TO: Mercedes-Benz Dealer Principals, General Managers, Sales Managers, Service Managers, Parts Managers	FROM: Gregory Gunther, Department Manager, Vehicle Compliance and Analysis, Engineering Services
RE: Recall Campaign Launch Notification Inspect Front Axle Wiring Harness MY19-22 G-Class (463 platform)	DATE: April 6, 2023

Inspect Front Axle Wiring Harness

Campaign No. 2023030005, April 2023

Inspect Front Axle Wiring Harness

Figure 4

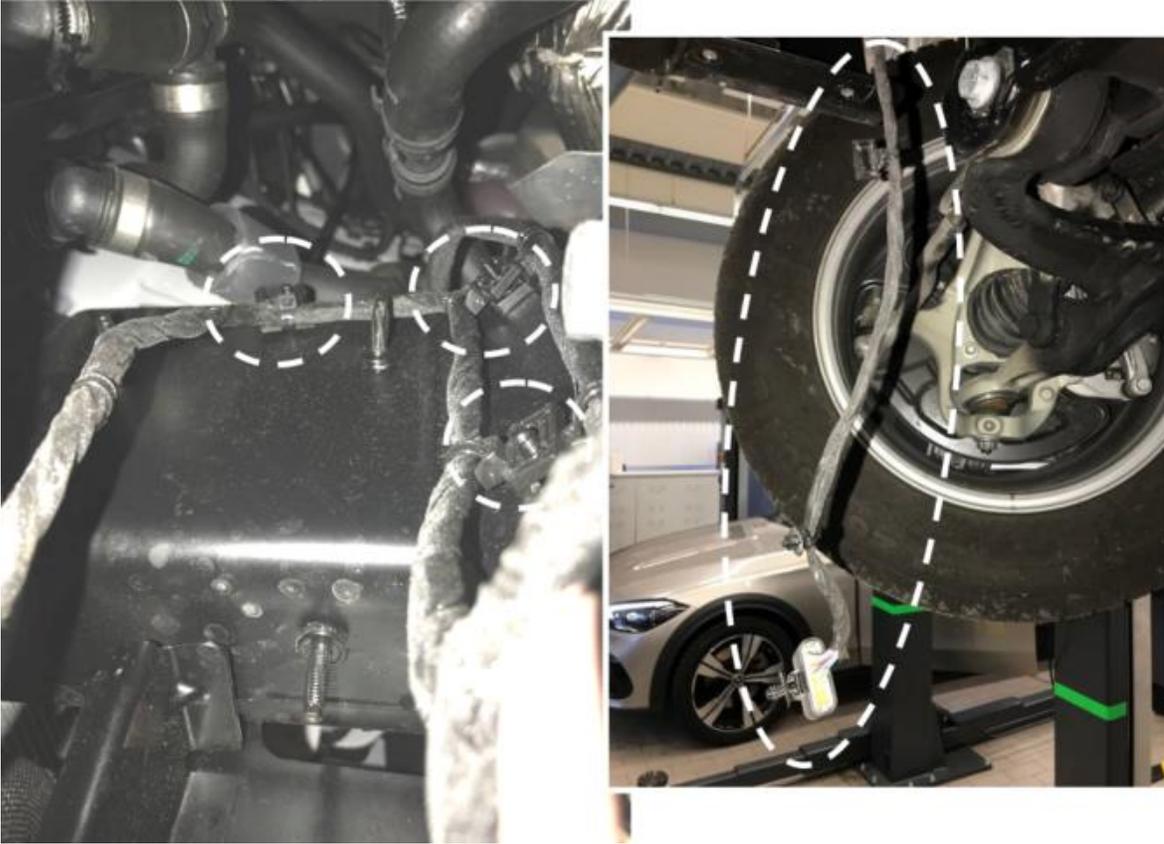
5. Unclip wiring harness from wheel arch at right trailing arm and place inwards in engine compartment (Figure 4).

i Hang wiring harness downwards vertically.

i For V8 engines, the retaining clamp (D, Figure 5) of the circulation pump must **also** be removed, press circulation pump slightly to one side to access the wiring harness.

Figure 6

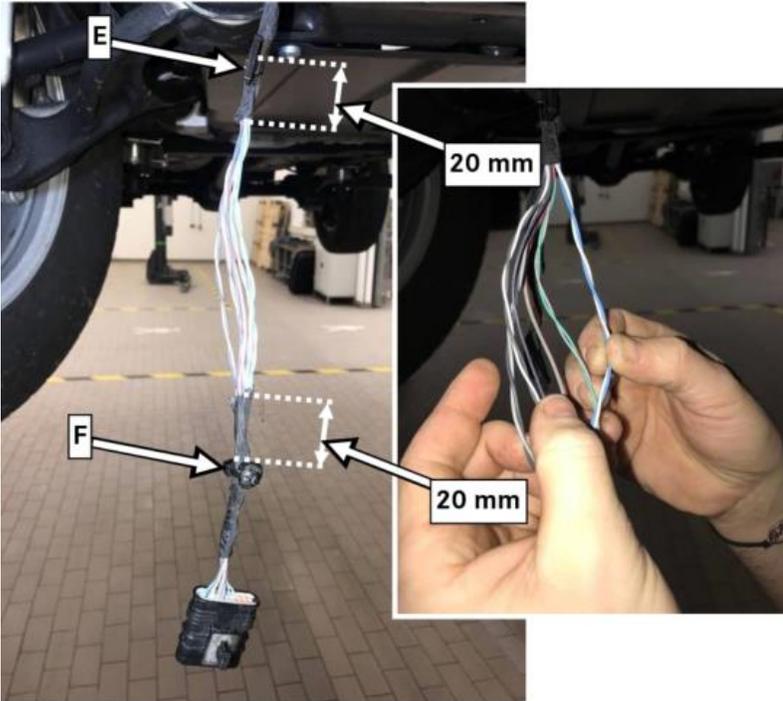
6. Remove the fabric insulating tape between the cable ties (E and F, Figure 6) and check all exposed individual cables for damage.

i Leave approx. 20 mm fabric tape in front of the cable ties in each case!

- a. If none of the individual cables in the exposed area are damaged: Carry out Work Procedure A.
- b. If one or more individual cables in the exposed area are damaged: Carry out Work Procedure B.

Figure 6

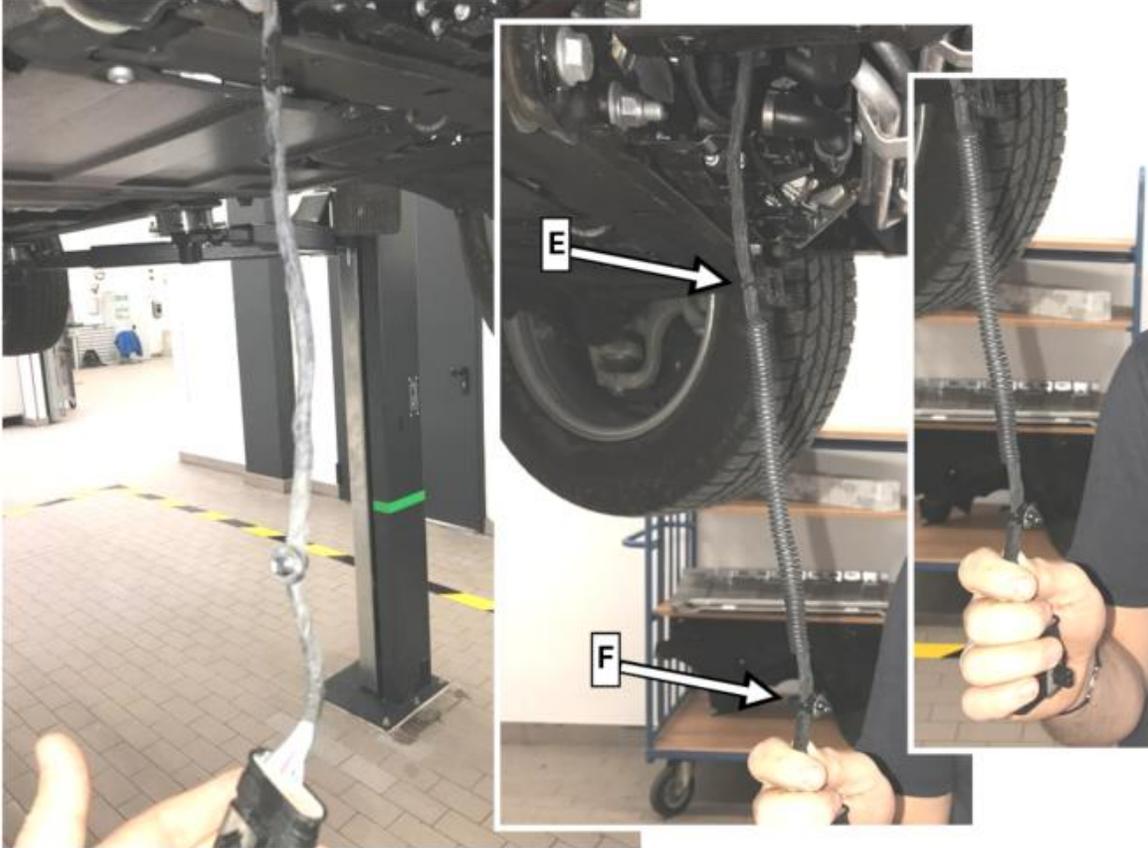
1. Freshly wrap exposed individual cables with fabric insulating tape and attach anti-chafe hose to wiring harness between the cable ties.

i Anti-chafe hose is supplied with a slit.

i Install anti-chafe hose such that the distance to the cable ties (E and F Figure 7) is identical.

2. Wrap the anti-chafe hose at the ends with fabric insulating tape to the wiring harness (Figure 8)
